Public Works Department – Engineering Division

ADDENDUM NO. 5

PROJECT 5067 WTP FILTER IMPROVEMENTS AND HYPOCHLORITE CONVERSION

④ CONDENSATE DRAIN DETAIL
 SCALE: NONE

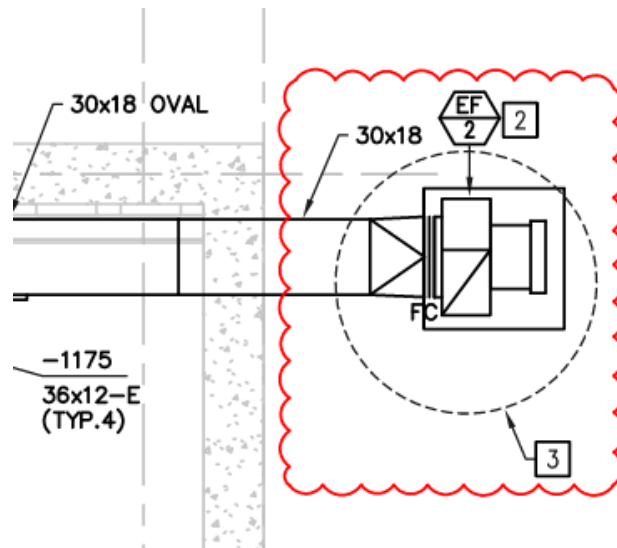
10. On Drawing GH004, replace Detail 4 with the detail below:

NOTES:

1. PROVIDE TRAP AS SHOWN AT COOLING COIL DRAIN CONNECTIONS.
2. PRIME TRAPS PRIOR TO STARTING FAN, AND AGAIN WHEN FAN IS IN CONTINUOUS OPERATION.
3. PROVIDE CLEANOUTS IN CONDENSATE LINES AT ALL CHANGES IN DIRECTION ALONG ITS ENTIRE LENGTH TO PERMIT CLEARING OF ANY BLOCKAGES.

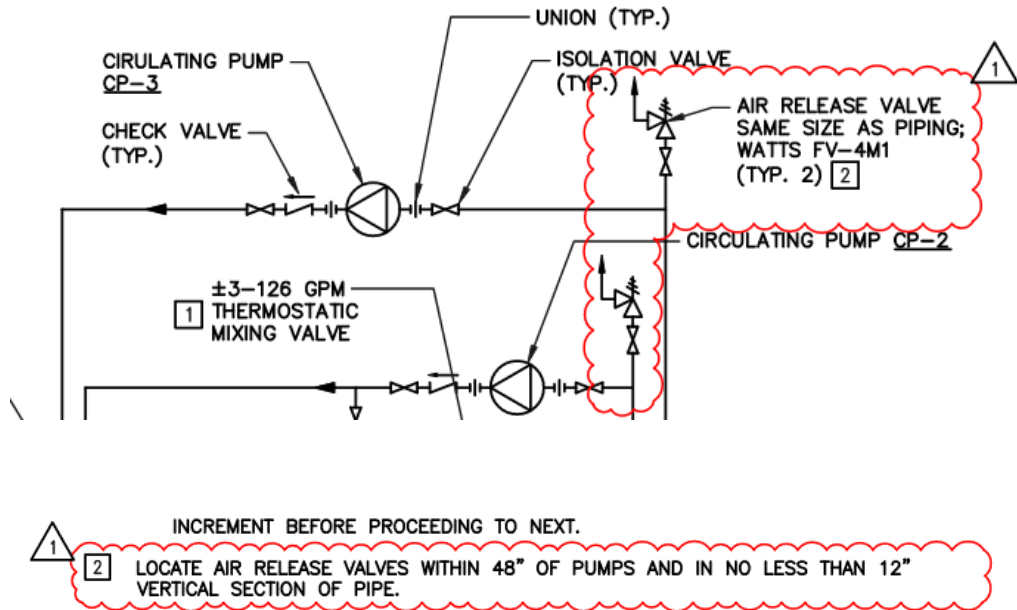
11. On Drawing H103, Sheet 1 of 9, change the Total Unconditioned Floor Area from "0" to "1,666".
12. On Drawing H301, add following Sheet Note 3 "Exhaust duct termination shall be not less than 3 feet from a property line, 10 feet above a public walkway, and 3 feet from openings into the building." Added 3 feet clearance area around EF-2, shown below.

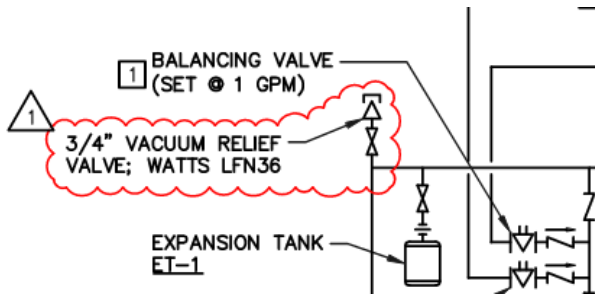
20. On Drawing GPL003, Detail 1, add air release valves.

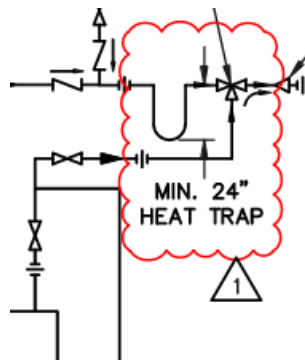
21. On Drawing GPL003, Detail 1, add a vacuum relief valve.

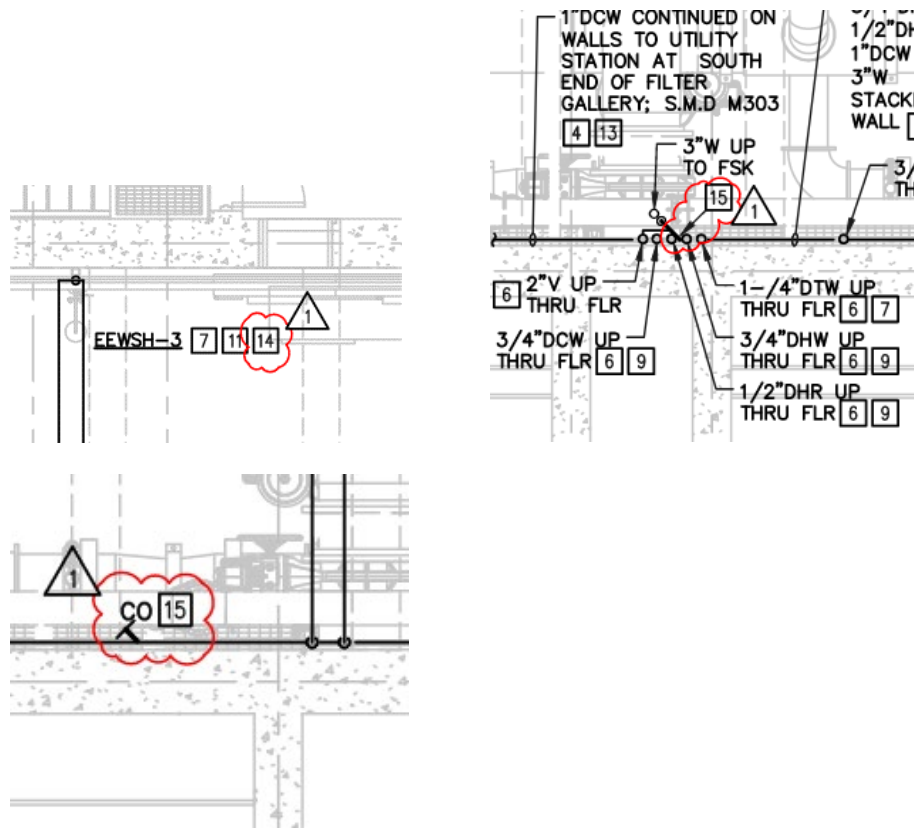
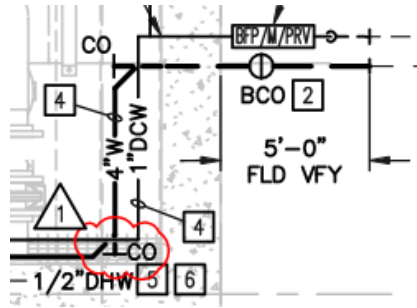
- 23. On Drawing GPL004, Sheet 1 of 7, add the address of the plant: "300 Olympia Drive, Pittsburg, CA 94565"
- 24. On Drawing PL300, add the following sheet note: "14. Path of travel to the eyewash station(s) shall be free of obstructions and clearly identified by signage. The eyewash station must be installed in accordance with the manufacturer's installation instructions."
- 25. On Drawing PL300, add the following sheet note: "15. Provide in and end of line cleanouts at midpoint and end of 100 feet runs of sanitary waste piping."
- 26. On Drawing PL300, add tags for sheet notes 14 and 15 to lower level plan.

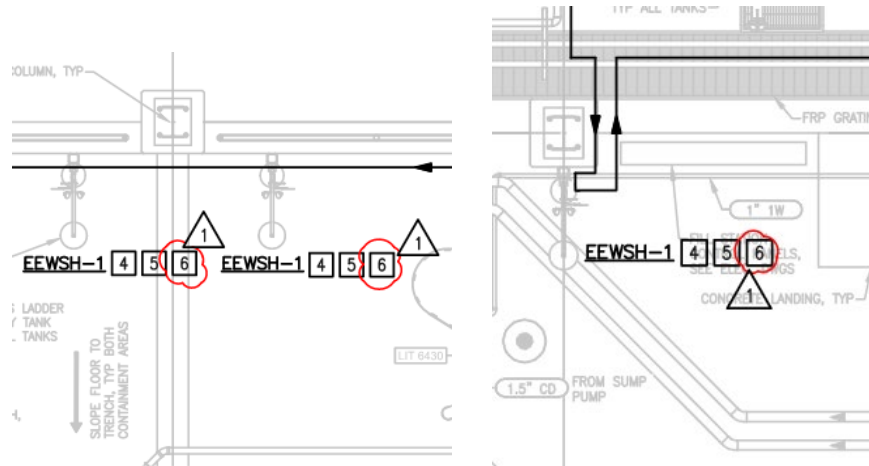
- 27. On Drawing PL300, add end of line cleanout to lower level plan at change in direction.
